**HUMBOLDT STATE UNIVERSITY
JENKINS HALL**

SEISMIC EVALUATION

SEISMIC DEFICIENCIES AND PROPOSED MITIGATION

Reference: Seismic Peer Review
Seismic Evaluation of Jenkins Hall – Humboldt State University
[Estructure No. 15200.25]

FOUNDATION PLAN
Scale 1/4" = 1'-0"

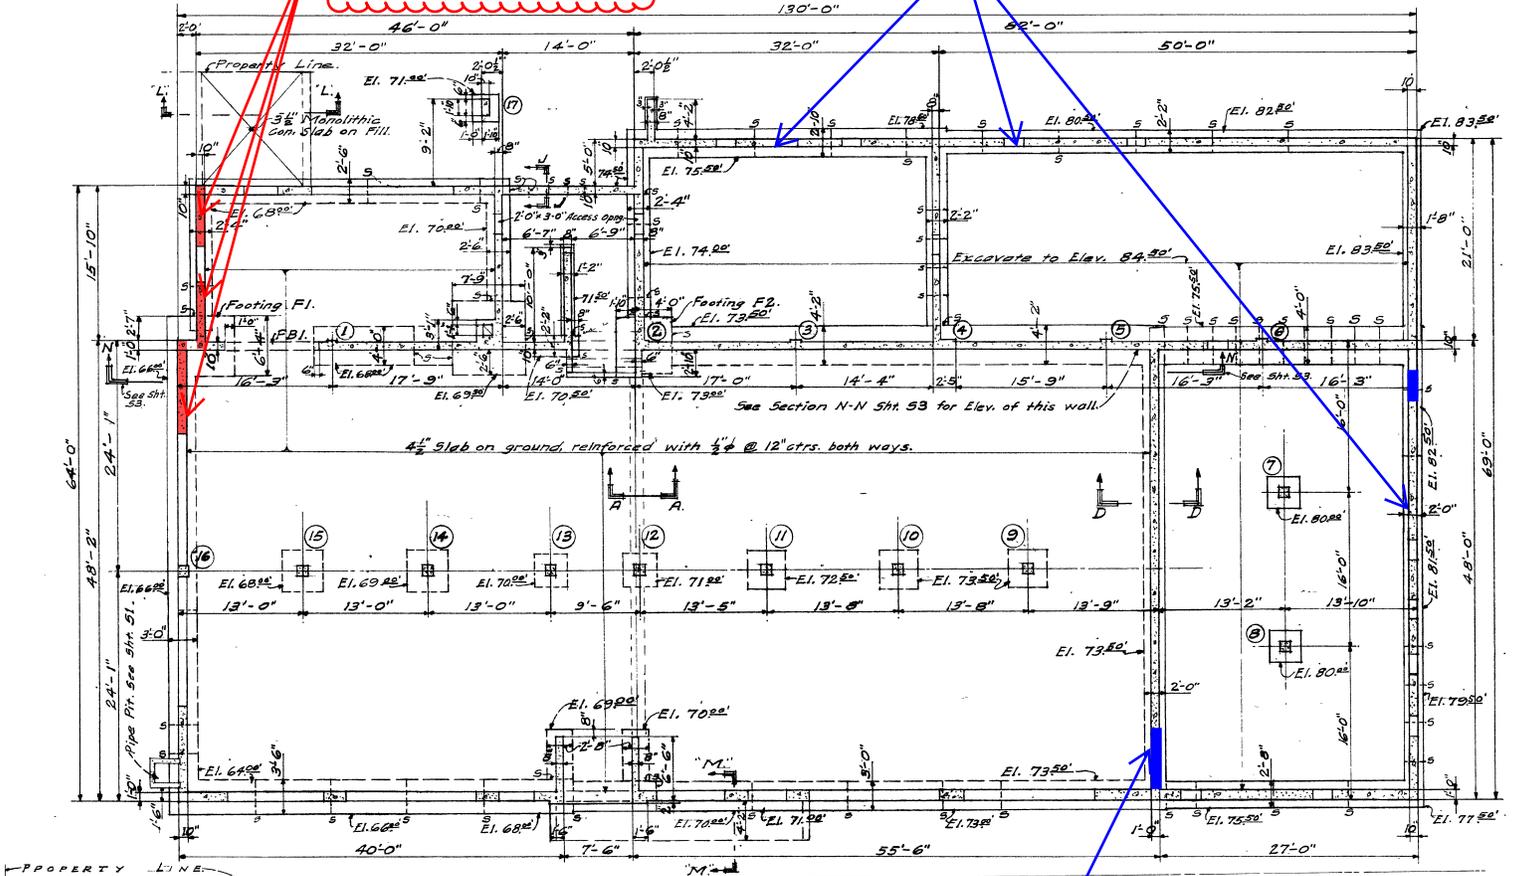
EXISTING STEPPED FOOTINGS EXPOSED IN ROOMS PROPOSED FOR RENOVATION: CANNOT DEMO WITHOUT EXTENSIVE FOUNDATION SHORING, UNDERPINNING AND RECONSTRUCTION

WALL PIER DEFICIENCY: INCREASE SIZE FOR ADDED STRENGTH

NEW OPENING IN CONCRETE WALL PER CURRENTLY PROPOSED RENOVATION SCHEME, TYP

FLOOR FRAMING PLAN.
Scale $\frac{1}{4}'' = 1'-0''$

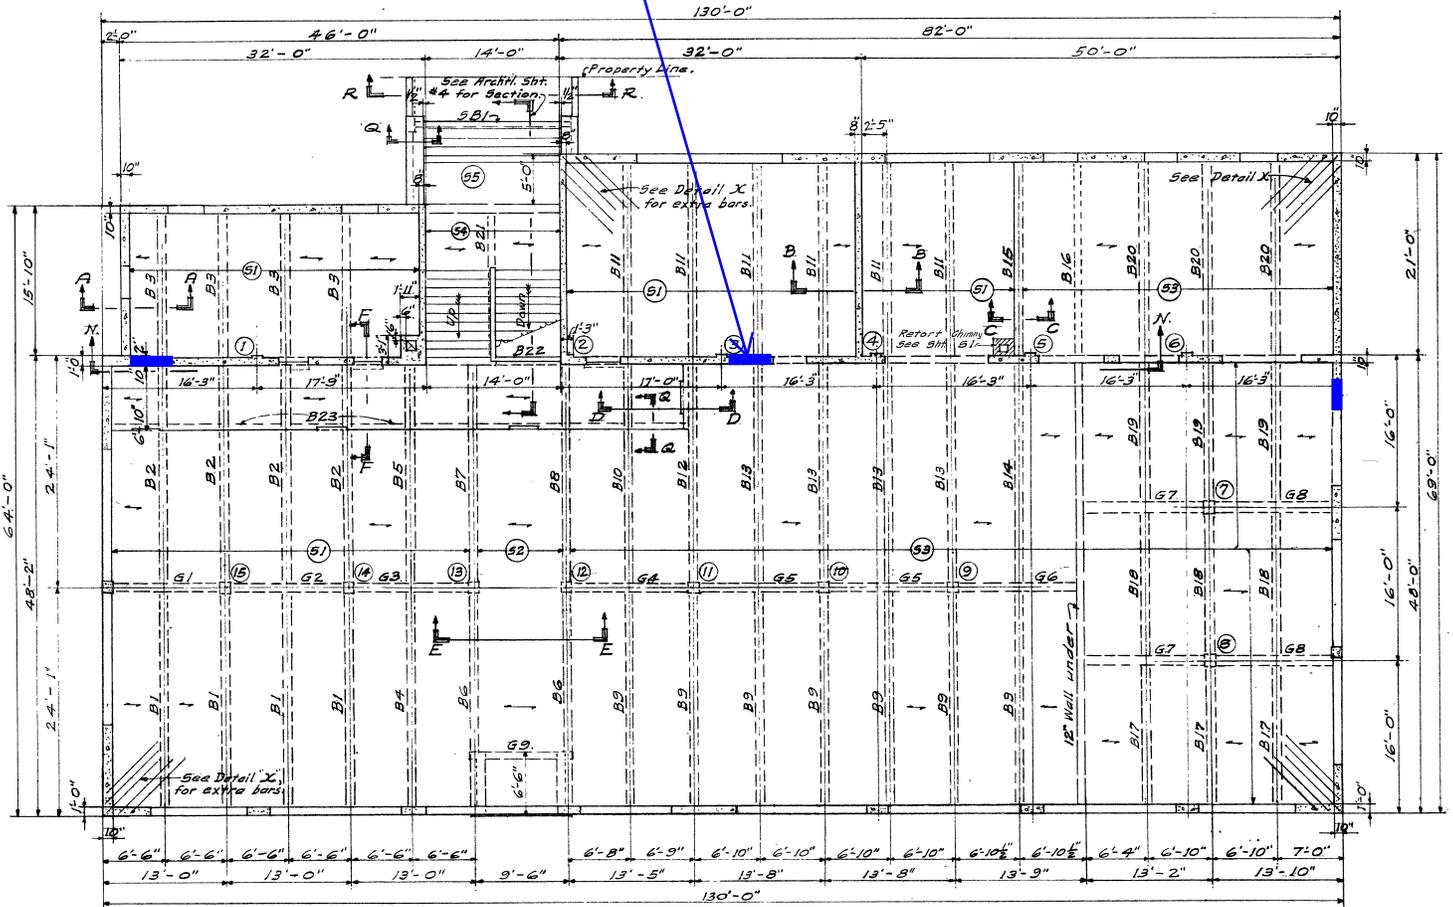
NEW OPENING IN CONCRETE WALL
PER CURRENTLY PROPOSED
RENOVATION SCHEME, TYP

NO RETROFIT SCOPE AT THIS LEVEL

ROOF FRAMING PLAN.
 Scale: 1/8" = 1'-0"

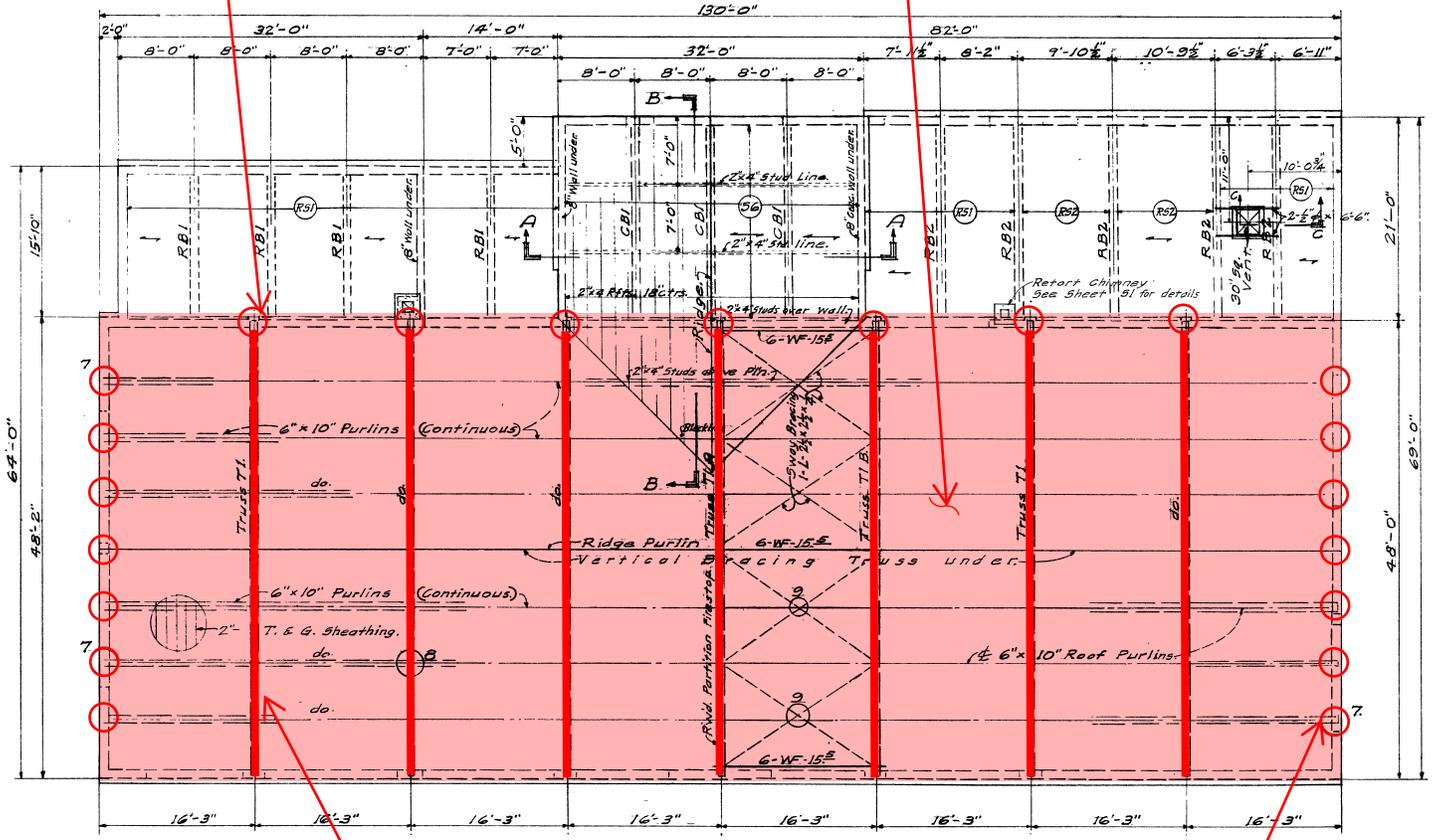
DIAPHRAGM TIE DEFICIENCY:
 PROVIDE NEW CONNECTIONS BETWEEN
 WOOD AND CONCRETE DIAPHRAGMS,
 TYP AT EACH TRUSS LOCATION

DIAPHRAGM DEFICIENCY:
 STRENGTHEN DIAPHRAGM BY
 PROVIDING NEW PLYWOOD
 SHEATHING OVER EXISTING 2x
 STRAIGHT SHEATHING

WALL ANCHORAGE DEFICIENCY:
 STRENGTHEN CONNECTION OF WALL TO
 PURLIN, TYP AT EAST AND WEST WALLS

WALL ANCHORAGE DEFICIENCY:
 PROVIDE NEW BLOCKING TO CONNECT
 DIAPHRAGM TO TRUSS, TYP AT EACH TRUSS
